Radiation Center

Subject: Additional Oregon State University Response to RAI Regarding License Renewal,
Oregon State University TRIGA Reactor dated May 21, 2007

Further Responses to RAI Letter of May 21, 2007

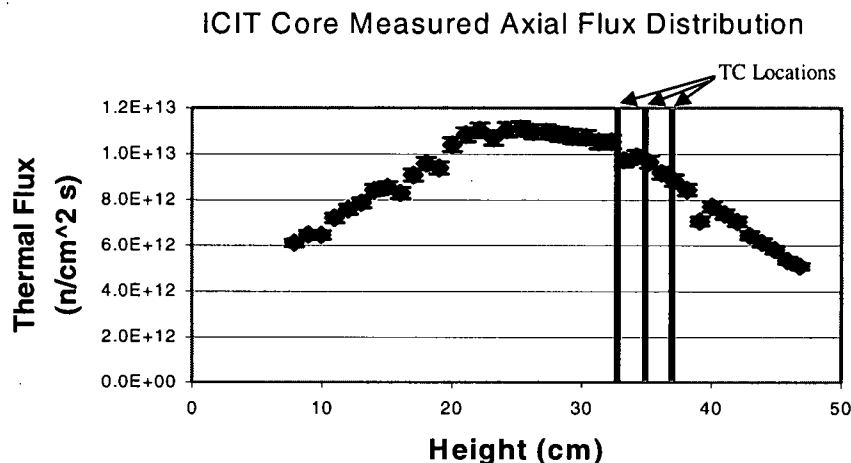
3. **What is the maximum fuel element power for possible core loadings (#8)? What are the peaking factors? Tables 4-11 and 4-12 only contain average power per element.**

The power per fuel element was calculated using MCNP5 with a model for a core similar to core #8 at a power of 1.1 MW. The new (MCNP5) model represents the reference HEU core (i.e., the original core loaded in 1976) and contains 4 less elements than core #8. The MCNP5 model for the reference HEU core was found to have very good predictive capability over a wide range of reactor conditions and was deemed to be well-suited for performing neutronics calculations. The results of this model can be seen in the following table:
